H12439

DESCRIPTIVE REPORT

Field No. OPR-Q191-KR-12

Sublocality North of Tigalda Island

Figure 2 Profile of 1P101-TIE03

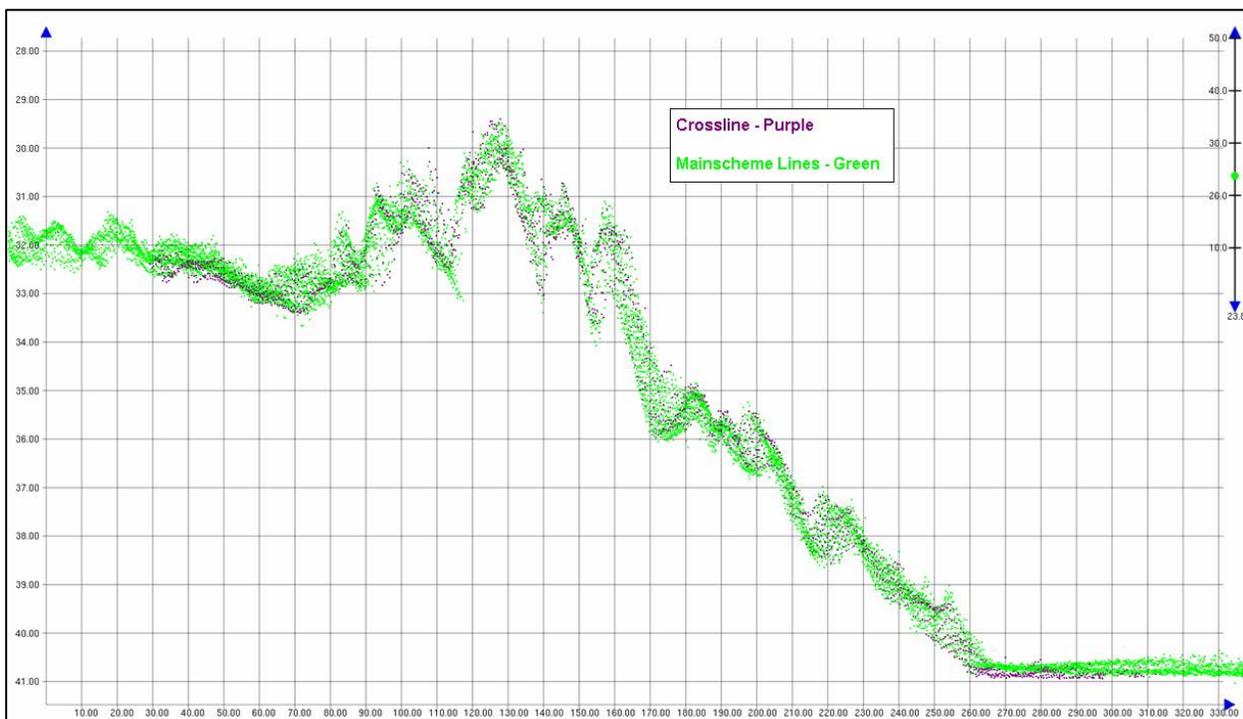
The majority of QC Reports fall well within the required accuracy specifications. However, several crosslines run by the Pacific Star in the northern part of Tigalda Bay contain beams in the QC report that fall below the 95% confidence level due to significantly rocky topography as illustrated in **Figure 2**. Good conformity was still seen between the mainscheme lines and crosslines. Mainscheme lines are shown in green and crosslines in purple. Quality Control Results are located in Separate II.²

² The effect of slope and rocky seafloor on confidence level are as expected. Resulting depths were used for updating the chart, but enclosed inside rocky area features as an added precaution.

Figure 7 H12439 Survey Junctions

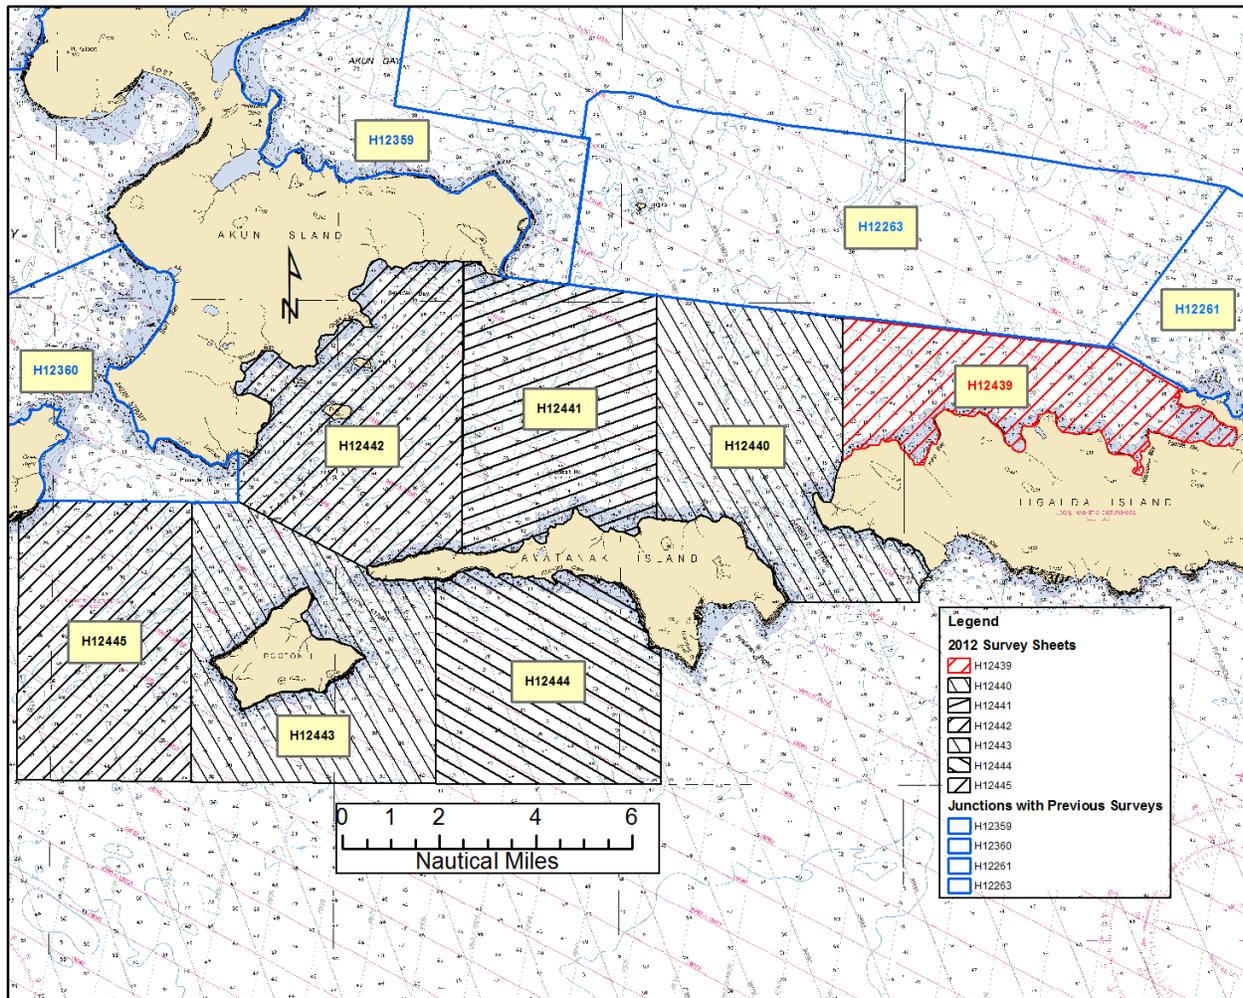
The surveys are in agreement along their common borders. The conformity between H12439 and the bordering survey areas (H12440, H12261, and H12263) was inspected during processing using the CARIS HIPS Subset Editor routine and finalized BASE Surfaces. Difference surfaces were also created between H12439 and the bordering survey areas and confirmed that approximately 92.2% of the nodes agree to within 0.35m. The other 7.8%, which were in the deeper portions of the sheet, agree to within 0.5m to 0.6m. These differences were usually on the

³ Survey H12439 junctions with 2012 survey H12440, and with 2010 surveys H12261 and H12263. Junctions have been completed with all three surveys for the chart update product.

Figure 8 Contours and Charted Soundings to be Modified in the ENC and RNC

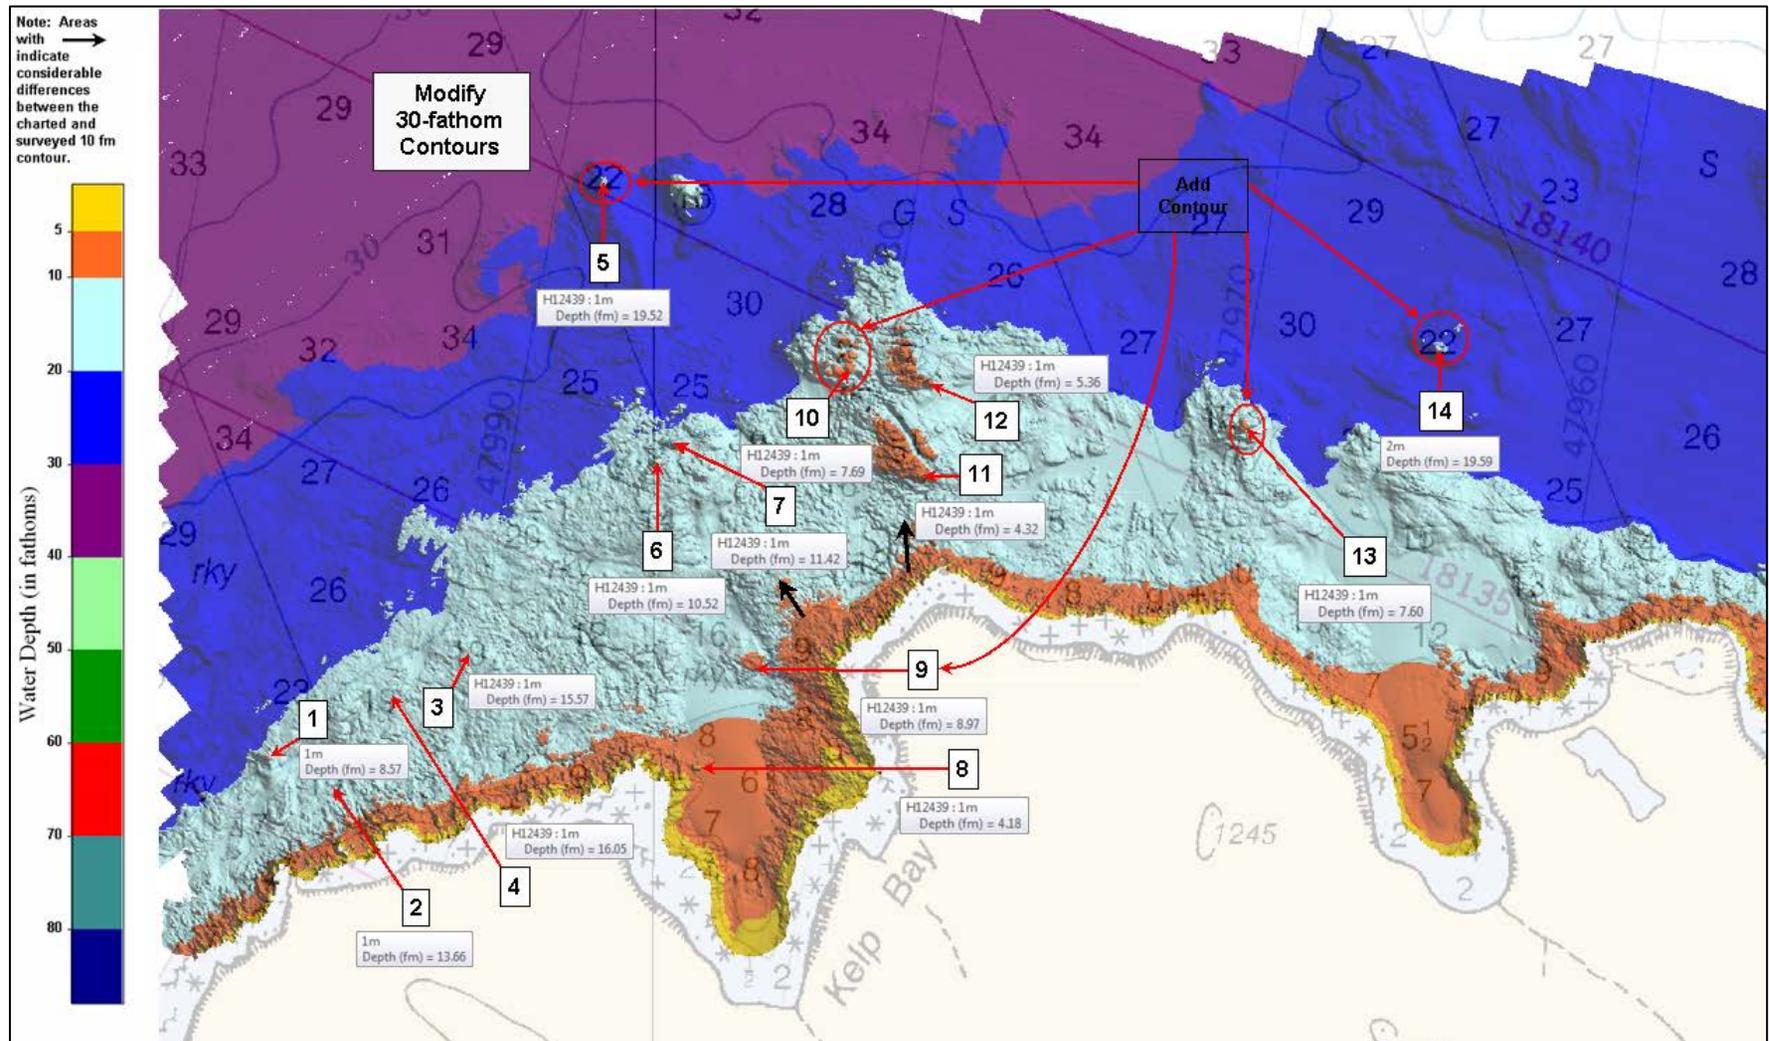
Contours in the area were adequate, but require revision from the high resolution data.⁸

1. Overall, the 100% multibeam coverage established discrepancies between charted and observed contours. New contours were discovered specifically around items 5, 9, 10, 13, 14, 22, and 23 as shown in **Figure 8** and **Figure 9** (coordinates listed in **Table 4**). Black arrows were positioned where the charted 10-fathom contour was considerably different from the surveyed depth (**Figure 10**).

⁸ Depth curves included in the chart update product are based on contours generated from the Combined BASE Surface, generalized as suitable for compilation to the largest scale raster chart.
